Updated: December 22, 2014

Attached are written comments and questions that EPA has received on the emissions factors proposed on August 19, 2014.

Figure 2: Calculated NOx Rate for Instantaneous Readings as Graphed from Column BF for Flare Test Associated with Flare FHR_AU

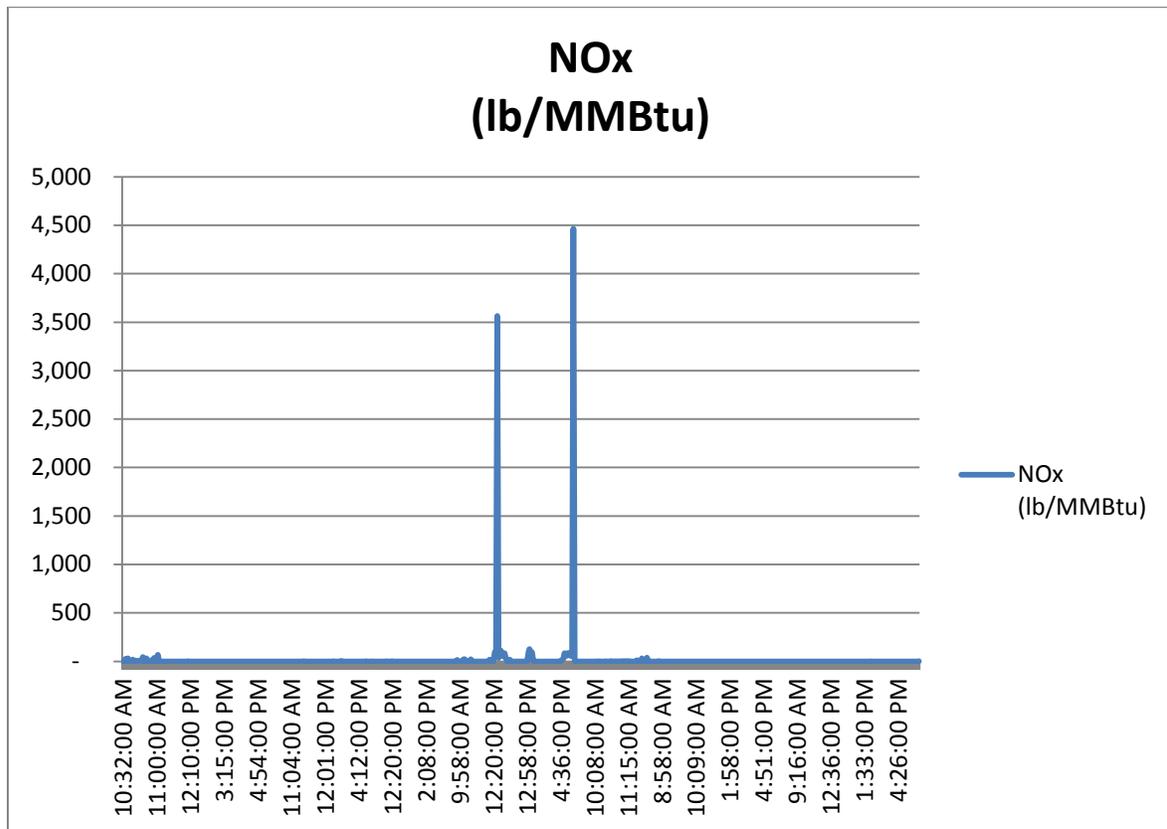
What EPA failed to do was evaluate the underlying large test data sets to see if there are outliers within each set. For example, in the file named “Flare Calculation.xlsx”, EPA reports the underlying instantaneous data from the performance test for flare FHR_AU. In the 639 minutes of reported data, there are two extremely high data points (approximately 3500 and 4500 lb/mmBTU). Within the dataset, there were instances where the flow reading left from a relatively stable value to a 100 to 300 fold increase over the period of a single minute and the instantaneous value was in a range that we question whether it could have been possible. For instance, the *lower of the two* went from 34,000 SCFM to over 1,500,000 SCFM. Was this a real value? Each exceptionally high NOx emission rate data point was associated with one of the instantaneous flow transients. The graphical representation shown in Figure 2 of the actual data from the test illustrates how these two points skewed the results significantly. Application of any accepted outlier test would have flagged these two points as outliers. Removal of just these two obvious outliers would have yielded a much different result, changing the value of 16 to 3.

Chart 5 - FHR-AU (Uncorrected) NOx lb/MMBtu

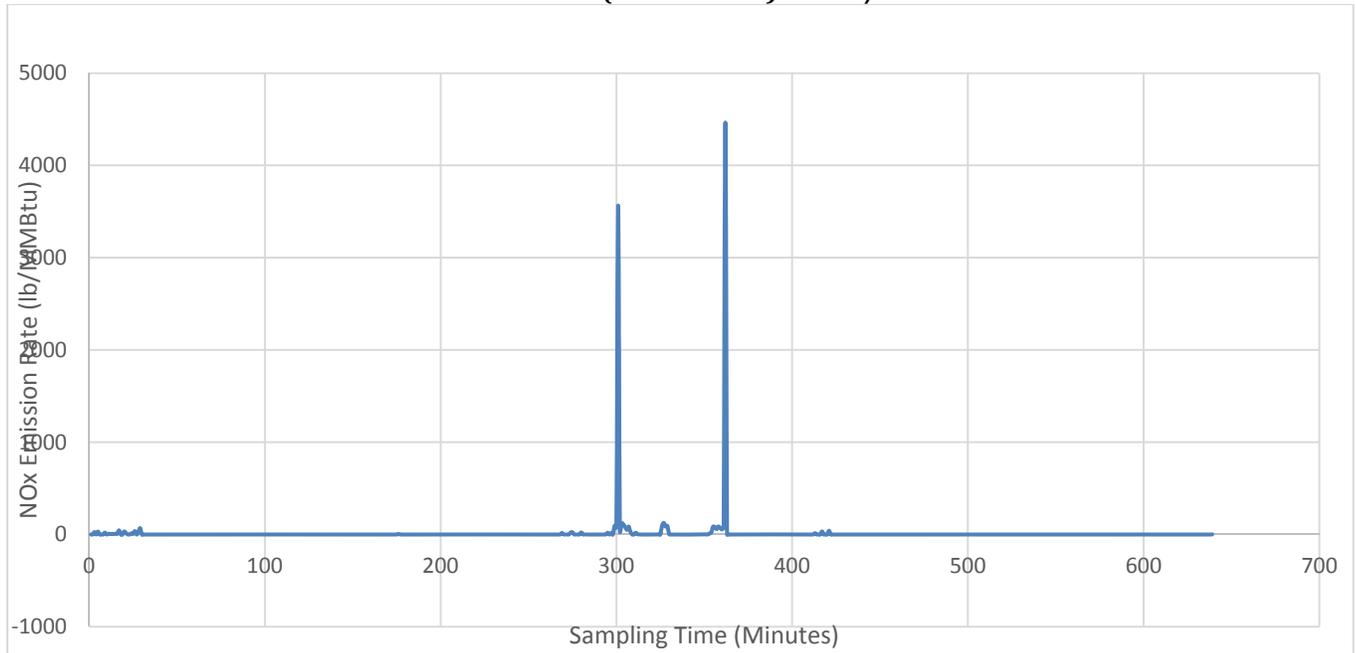
Two features chart 5 stand out: 1) the scale of the y-axis (0 - 5,000 lb/MMBtu) is far larger than any of the previous charts, and 2) that scale is made necessary by two large peaks that exceed other calculated by values by at least two, and in most cases three, orders of magnitude. But, even removal of these two anomalous data points yields a much different-looking chart:

Chart 6 - FHR-AU (2 Anomalous Data Points Removed) NOx lb/MMBtu

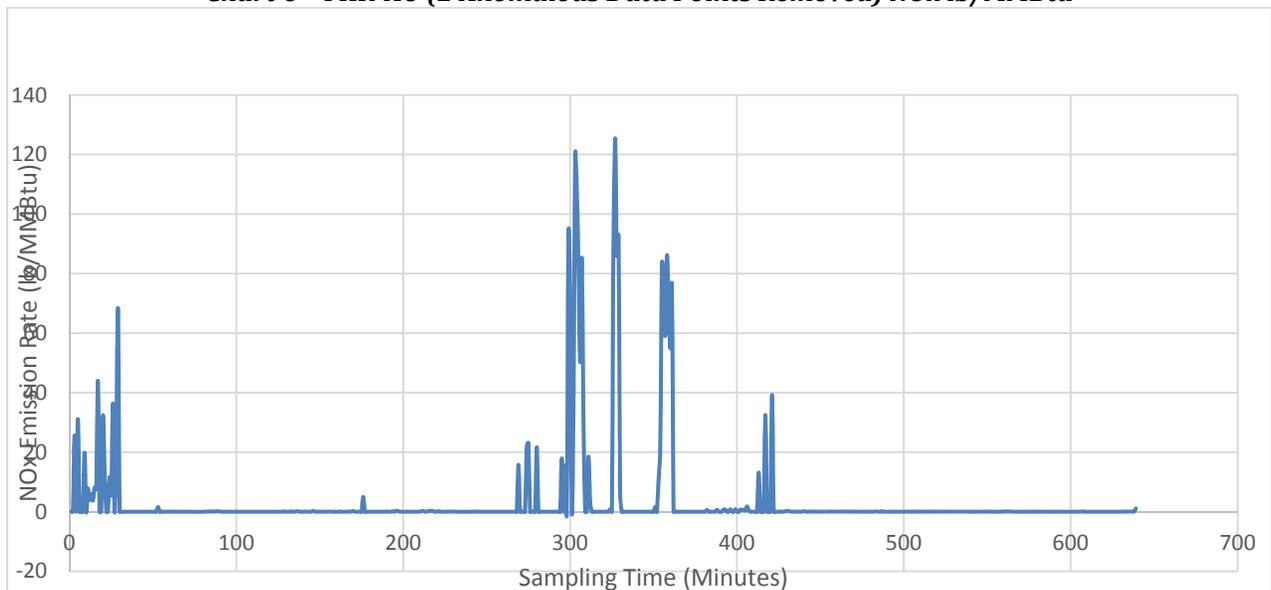
Chart 7 (below) provides a visual representation of the extreme variability in exhaust gas flow rate calculations in the FHR-AU case. Many of these erroneous calculations are problematic, because each erroneous flow rate calculation does not always correspond to a flaring event where NOx emissions are produced. But, when erroneous flow rate calculations do correspond to such a flaring event, an over-estimation of NOx emission rates inevitably occurs.

Chart 10 - FHR-AU NO_x, CO and Heating Value vs. Time

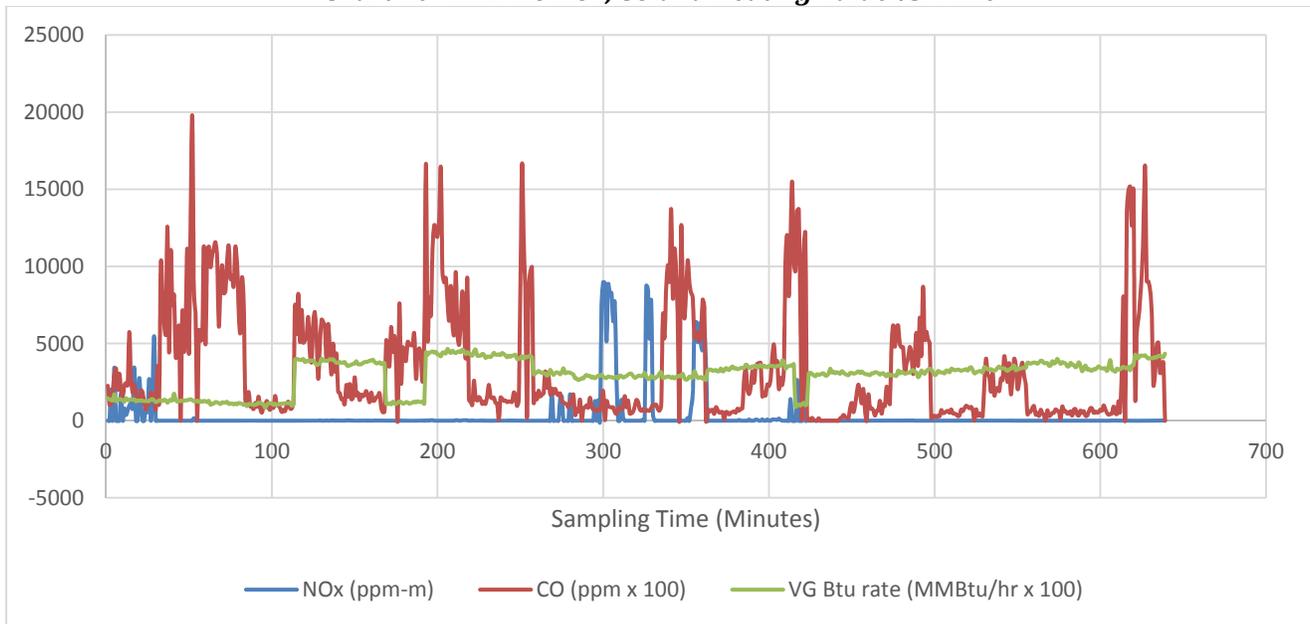
When the same data points are plotted for FHR-AU, a much different pattern emerges:

Chart 5 – FHR-AU (Uncorrected) NOx lb/MMBtu

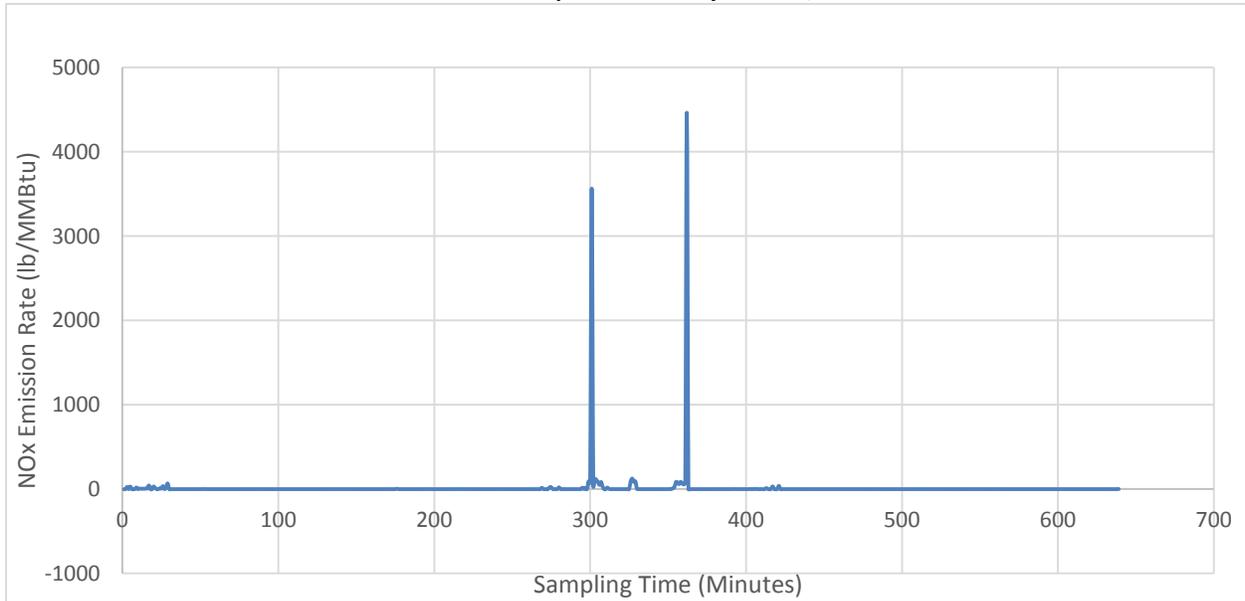
Two features of this chart stand out: (1) the scale of the y-axis (0 – 5,000 lb/MMBtu) is far larger than any of the previous charts, and (2) that scale is made necessary by two large peaks that exceed other calculated values by at least two, and in most cases three, orders of magnitude. Removal of these two anomalous data points yields a much different-looking chart:

Figure 1. Emission factors derived from TCEQ extractive flare test (propane test runs)

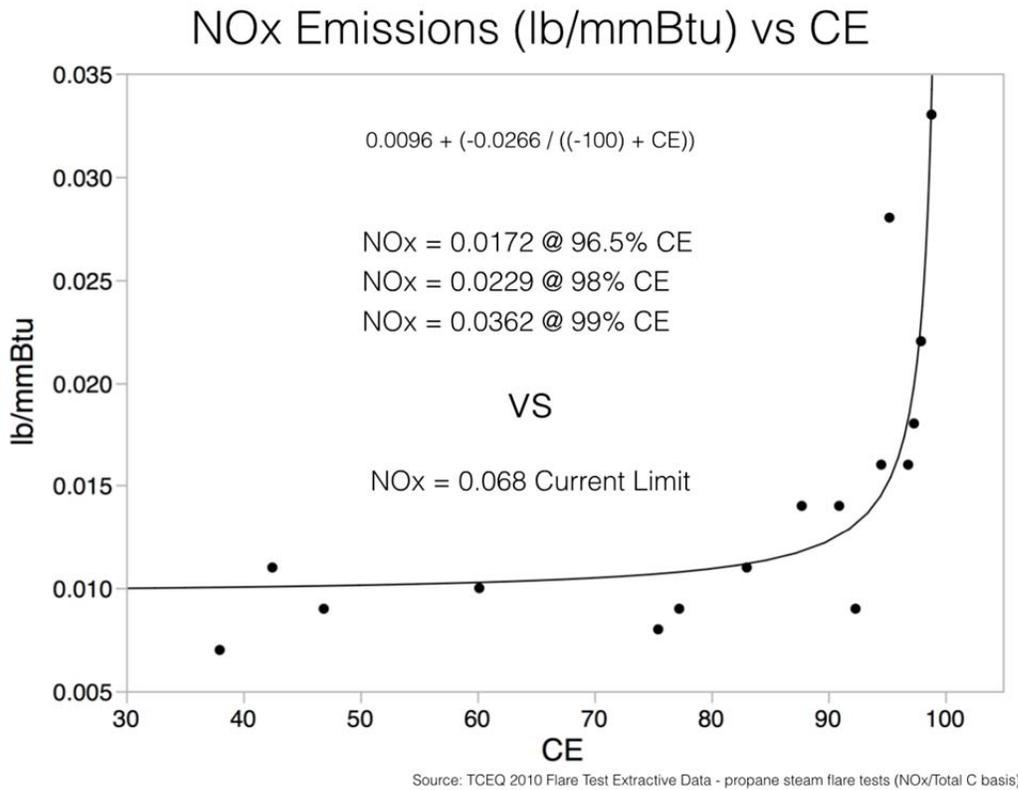
During the 2010TCEQ test extractive sampling was performed in addition to the PFTIR testing. While there were issues with extractive NO_x calibration during the propylene test runs, good NO_x data was collected during the propane runs. The extractive instruments were properly calibrated for NO_x during the propane test runs. The NO_x data are available from this test and described in the literature.² This data is shown in Figure 1 with a least squares curve fit.

Figure 4. Unweighted point combustion efficiency values compared to weighted run averages

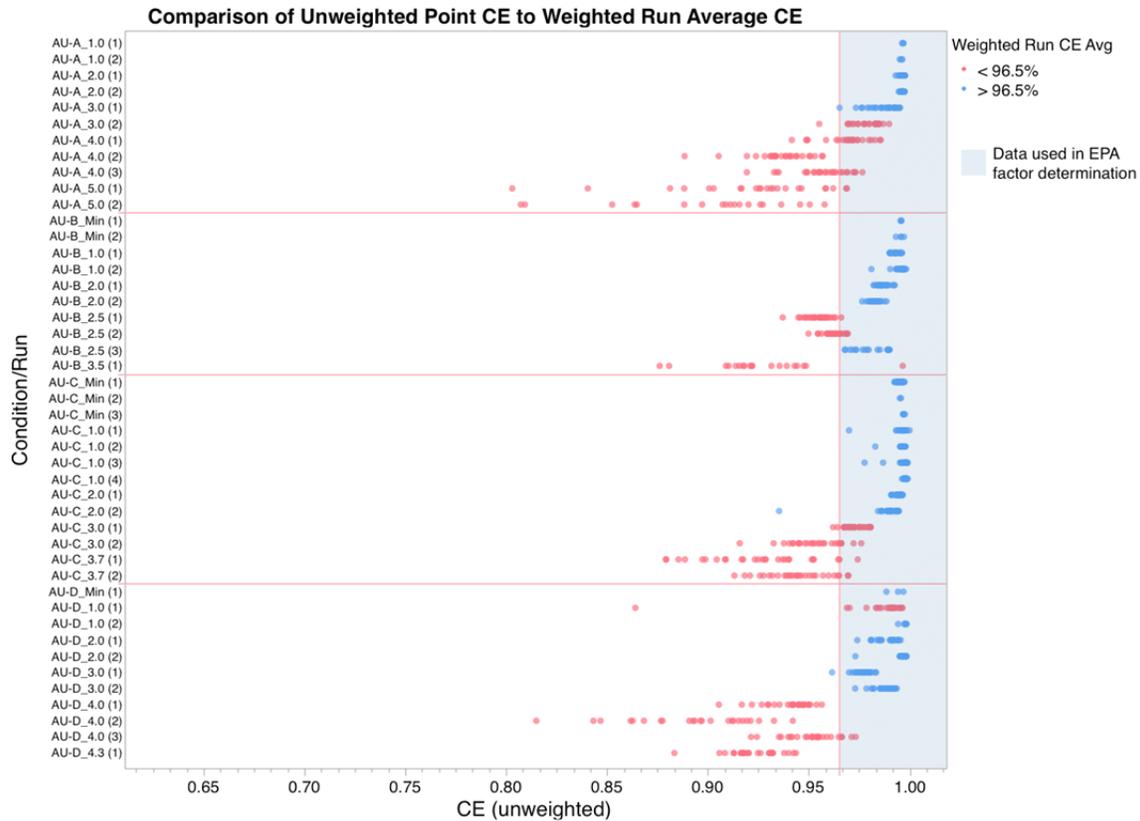
Also, as stated above, individual one-minute data points are not representative of actual flare combustion efficiency. Only the run averages provide a true indication of flare performance. Filtering the data by unweighted CE results in the inclusion of many data points from lower efficiency runs being in the analysis. This could lead to significantly different emission factors compared to use of weighted CE. Figure 4 shows a comparison of the unweighted one minute data points used for factor development (in the blue shaded area) and the run average efficiencies reported in the PFTIR testing.

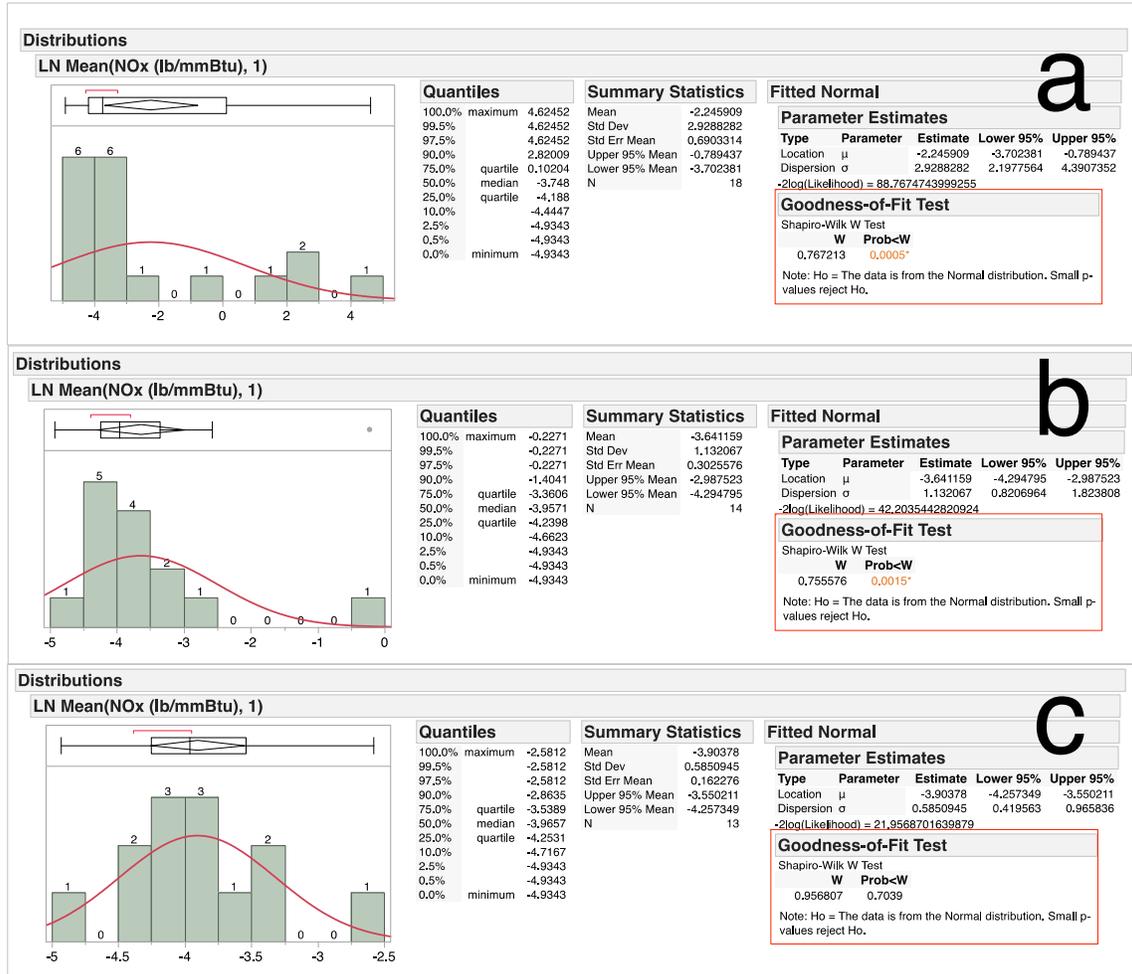
Figure A2(c) shows the same distribution with the fifth run removed. Now the data shows a normal distribution.
